AGENDA

PLANNED UNIT DEVELOPMENT-SPECIFIC IMPLEMENTATION PLAN REPORT TO THE PLAN COMMISSION

Statement of Owners Intent,
General Development Plan, and Specific Implementation
Plan for Ridge View Estates –
Lot 1 Multifamily Development

RIDGE VIEW ESTATES
MULTI FAMILY LANDSCAPE PLAN
SHEET: L-1
DATED: FEBRUARY 6, 2025

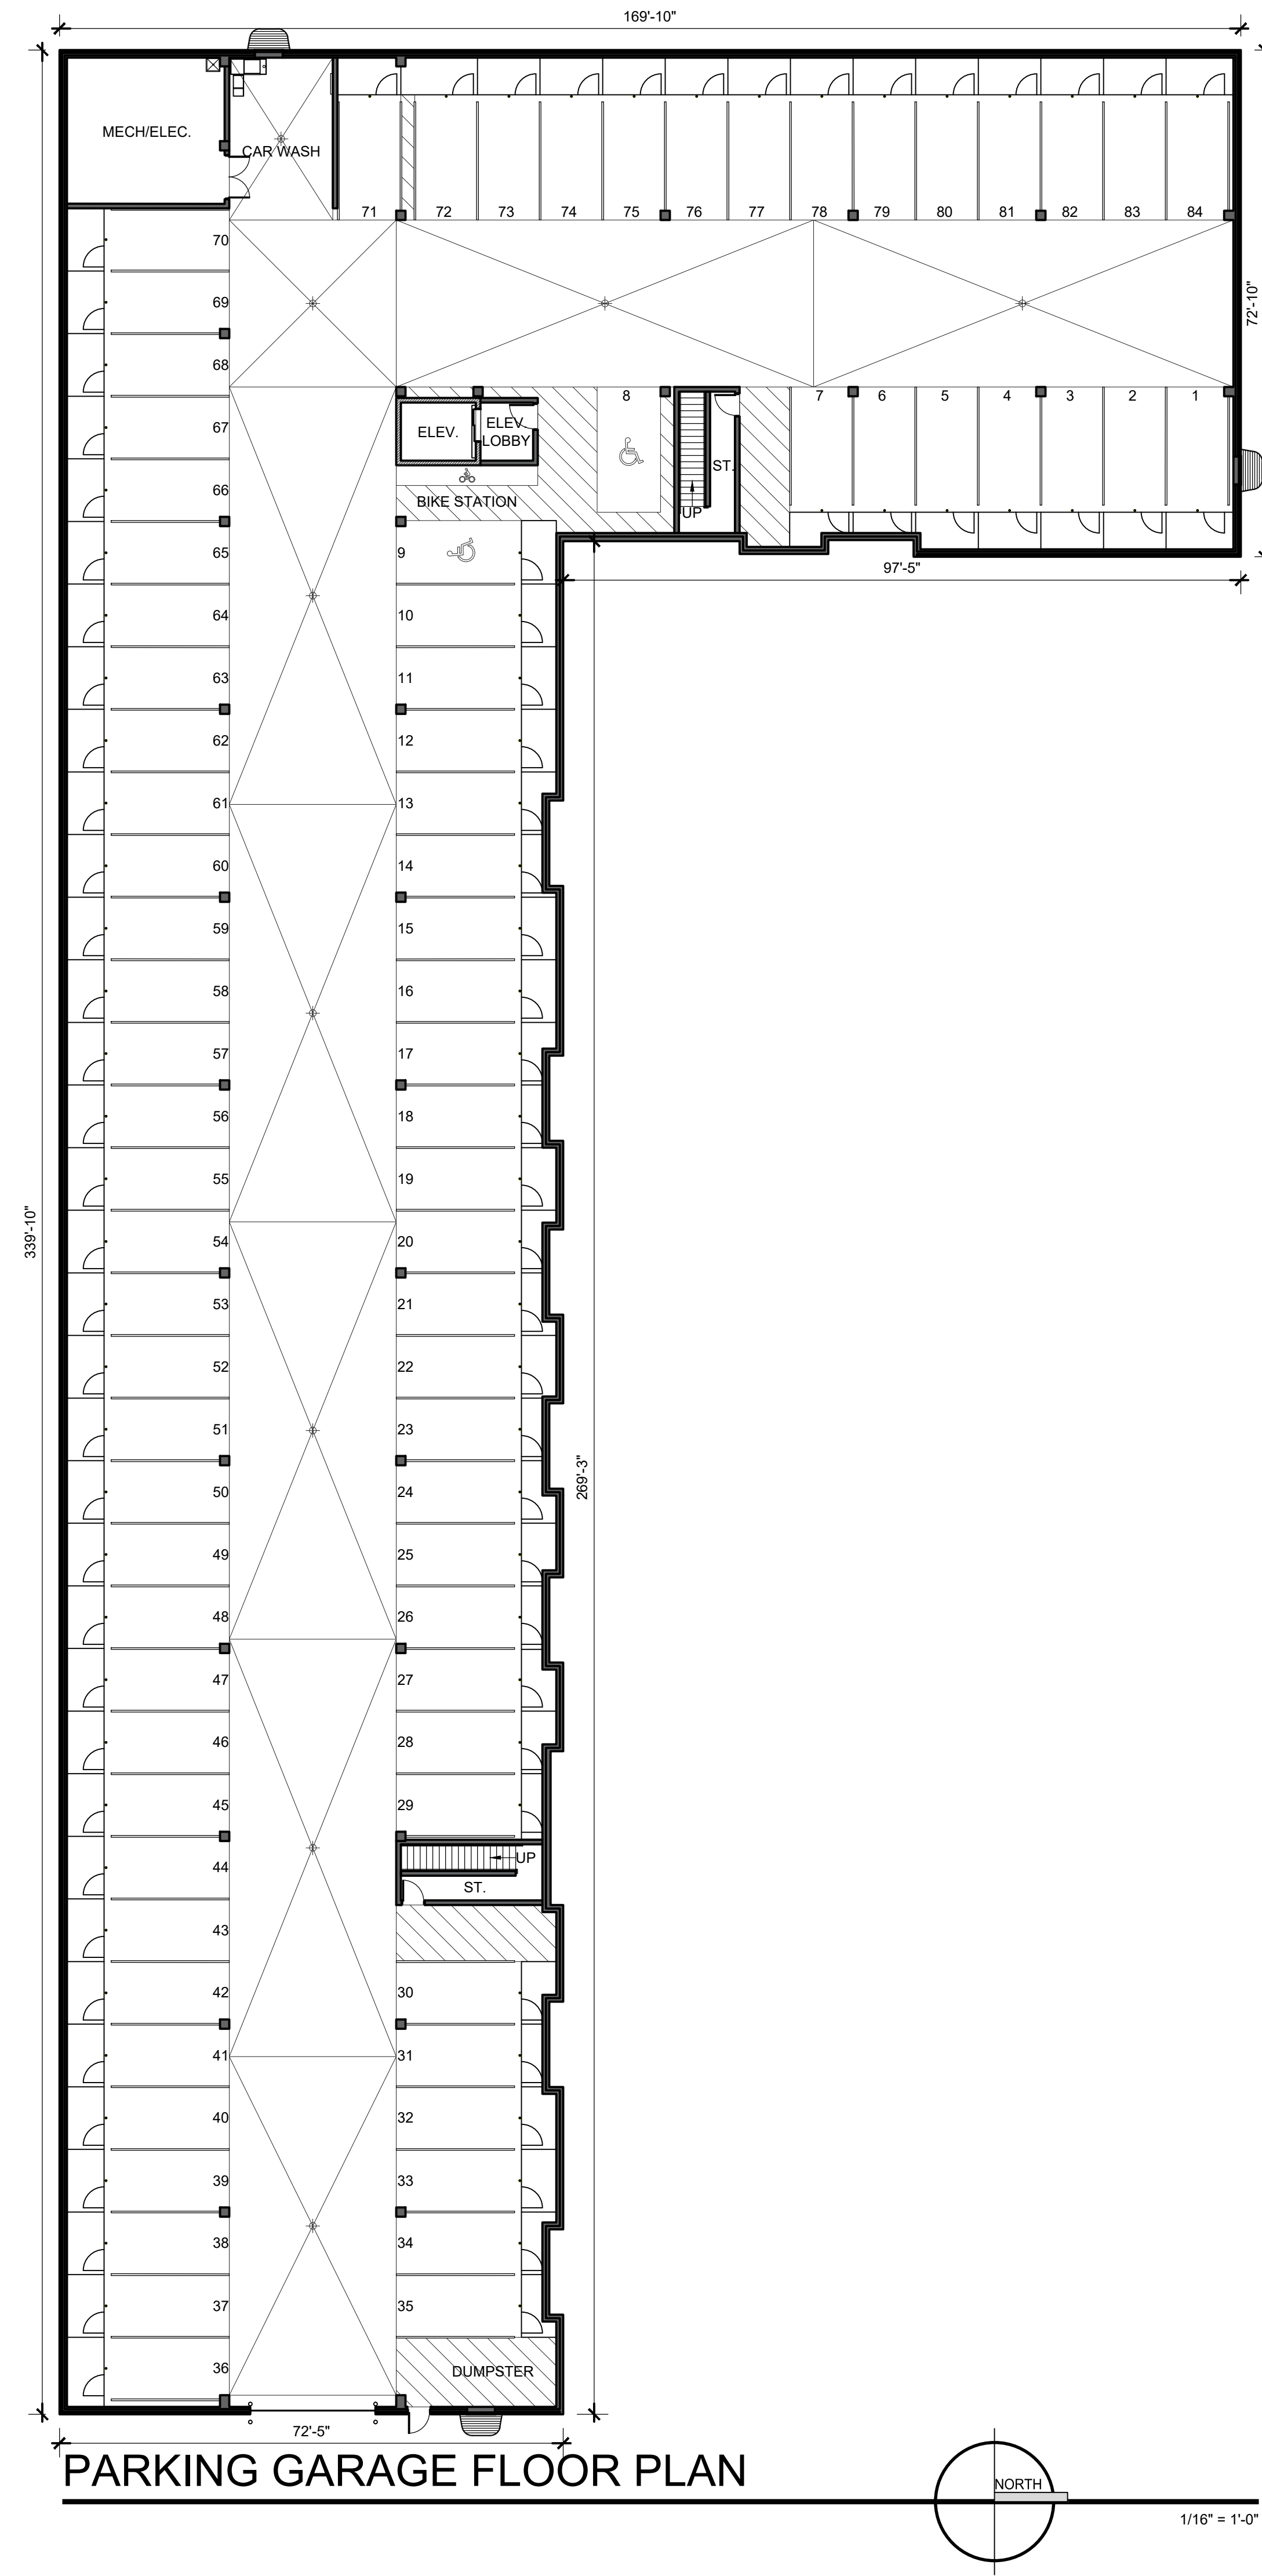
5. Require the applicant to meet the minimum street frontage landscaping points (540 proposed, 675 required).
6. Require an erosion control plan to be submitted to city staff prior to issuance of a building permit.

RIDGE VIEW ESTATES
MULTI FAMILY SITE PLAN
SHEET: C-1
DATED: FEBRUARY 6, 2025

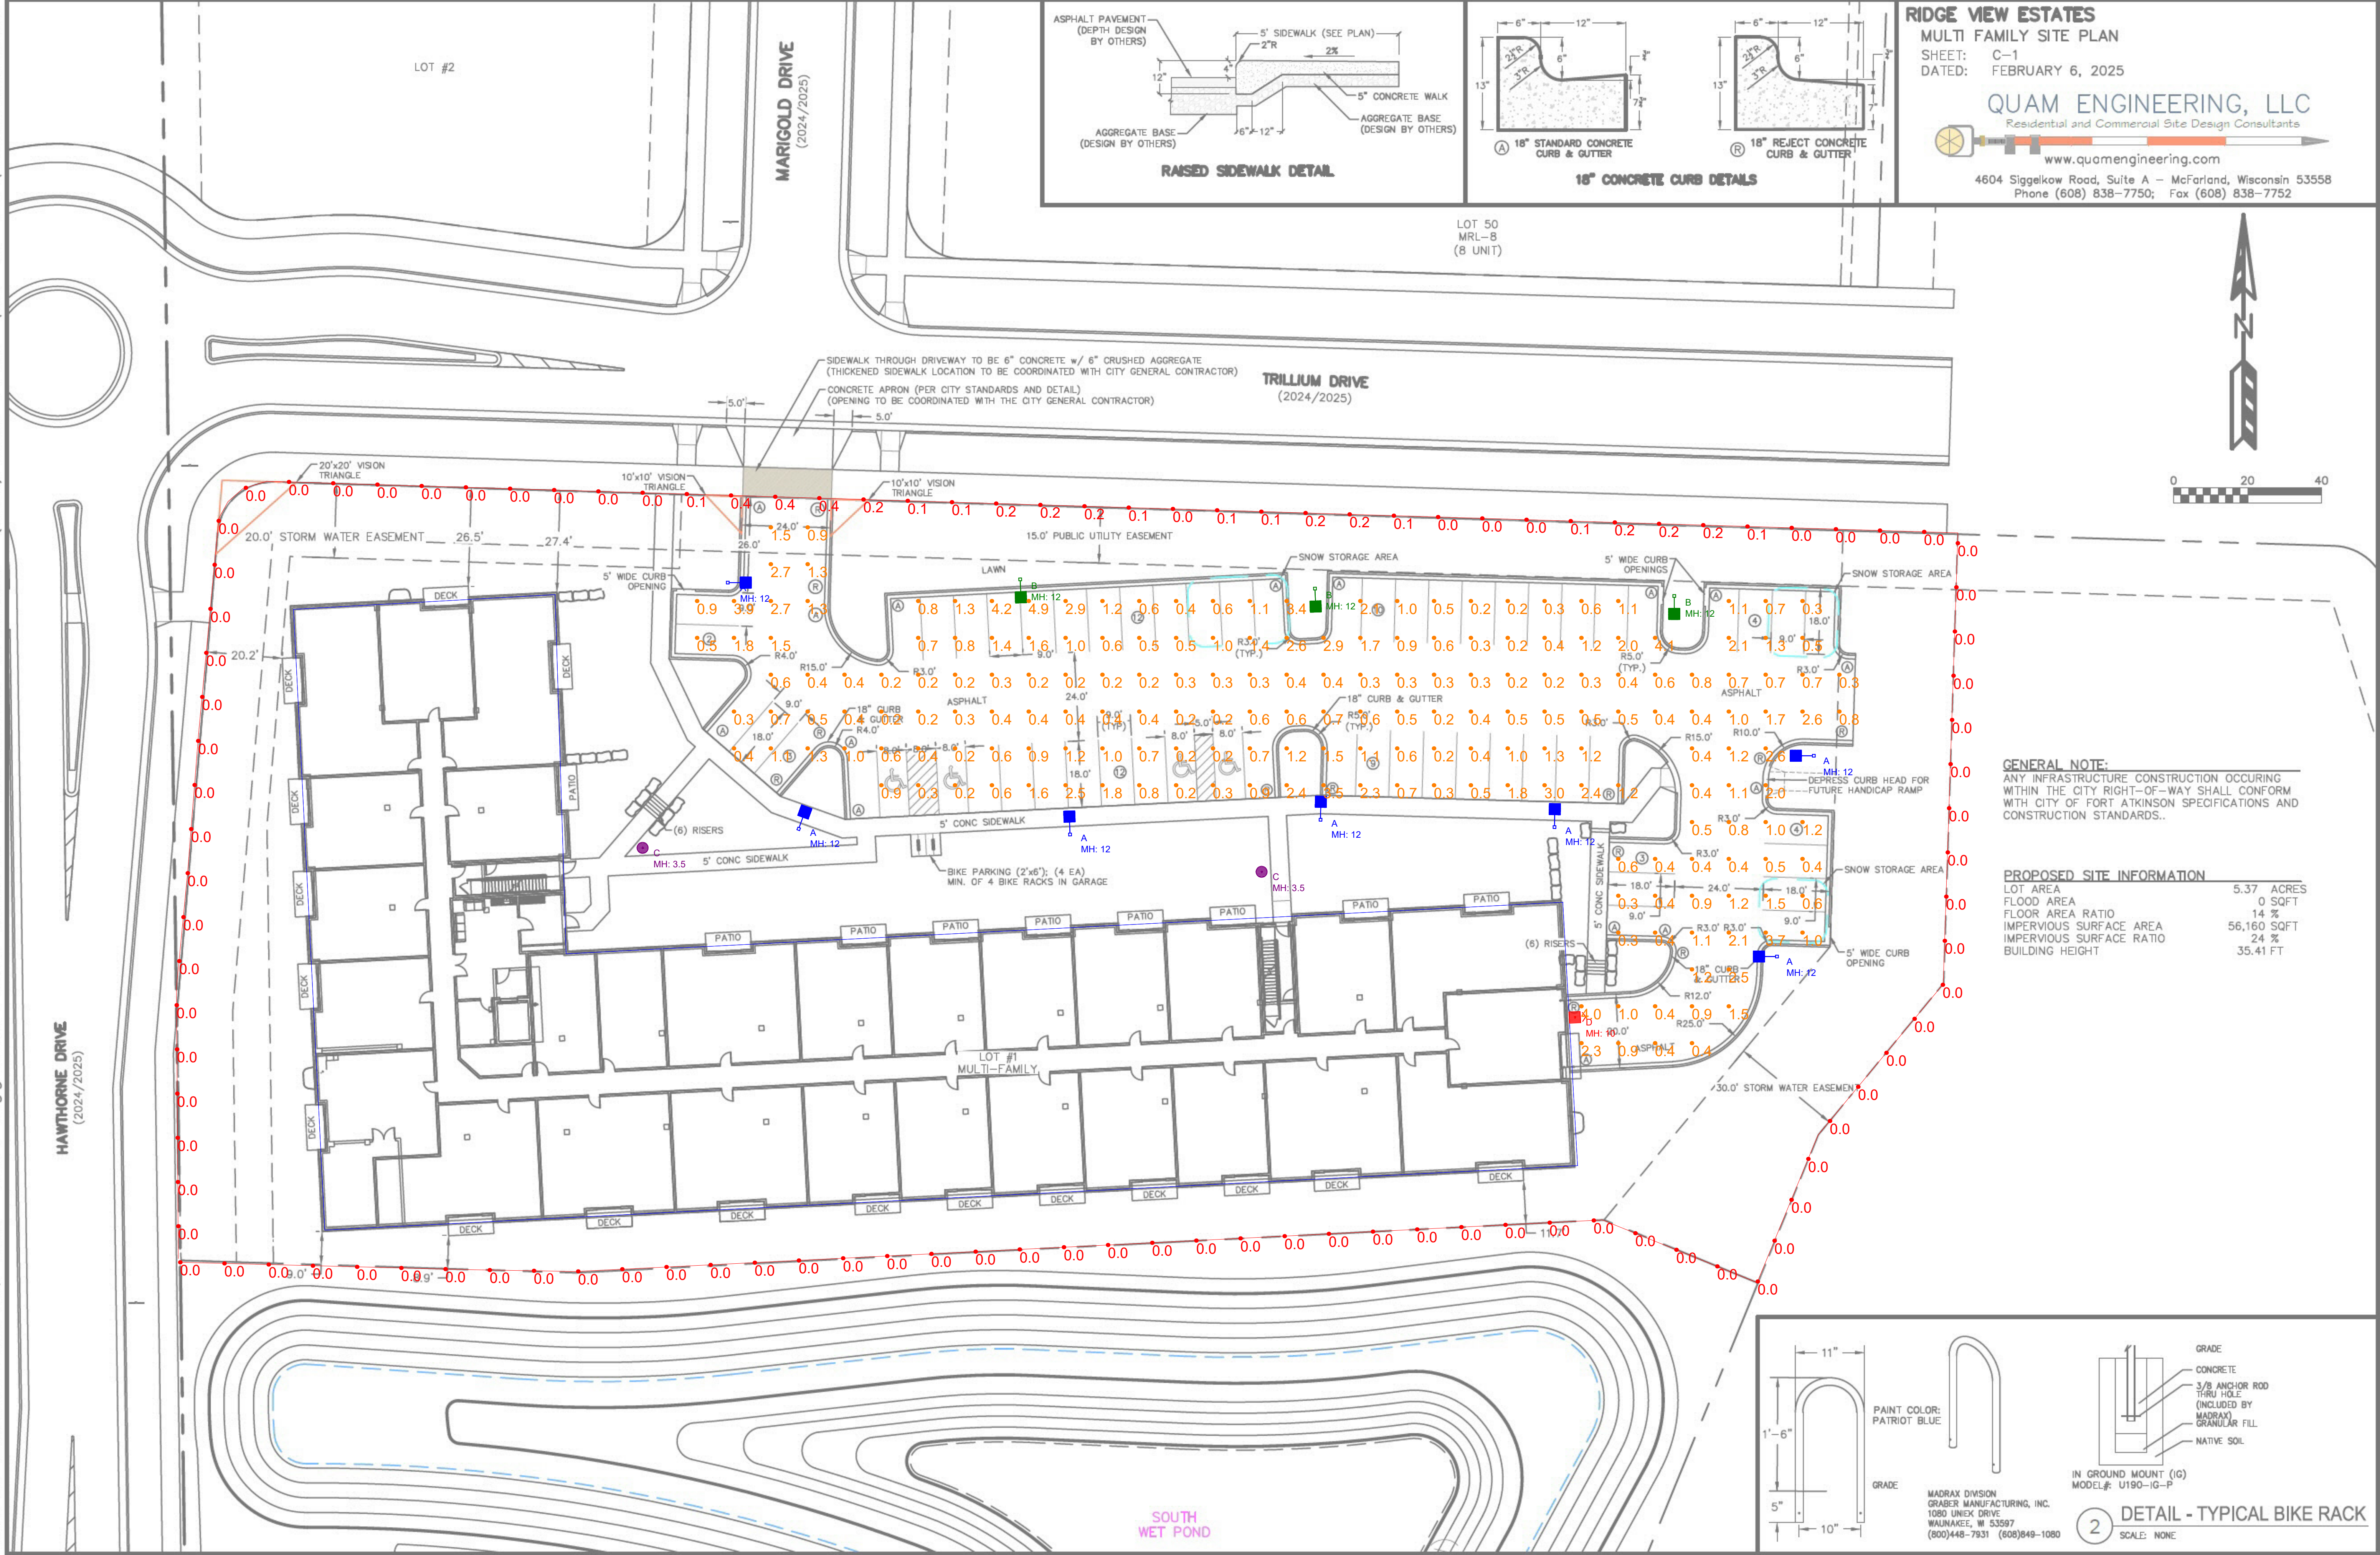
- Multiple access points from one street can be approved through the Site Plan process on lots greater than 200 feet long = met (one access point proposed)
- No access is permitted within 50 feet of an intersection = **not met (aligns with intersection of Marigold Drive and Trillium Drive)**
- Minimum driveway setback is 10 feet from the front lot line = met
- Maximum driveway size is 24 feet wide = met (24' proposed)
- At least one ped/bicycle access point to at least one street frontage is required = met
- All structures must be located outside of vision triangles at the right-of-way intersections = met

2. A finding that the Specific Implementation Plan is consistent with the approved General Development Plan.
3. Waive the requirement for no access within 50 feet of an intersection because the proposed access point aligns with the intersection of Marigold Drive and Trillium Drive to provide a uniform 4-way intersection.
